Business Unit: Electronics PCN/17/020/C+N

Product range: DC1 / D-Sub Date: 2017-08-24

Title: New tools for several D-SUB variants – External

Current Design	New Design
straight for PCB (with turned contacts and double shell construction)		
angled for PCB (with turned contacts and double shell construction)

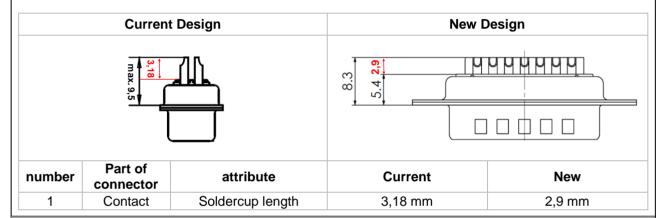
Change of process technology and manufacturing method.

- > With impact on:
  - Design
  - Packaging
  - Labeling of products
- Without impact on:
  - Technical functionality (electrical parameters, mechanical parameters)
  - Product specifications (CECC 75 301-802 & DIN 41652)
  - Compliance (e.g. RoHS, lead-free, etc.)
  - UL
  - Price

Current Design	New Design
Soldercup with turned contacts		
WireWrap
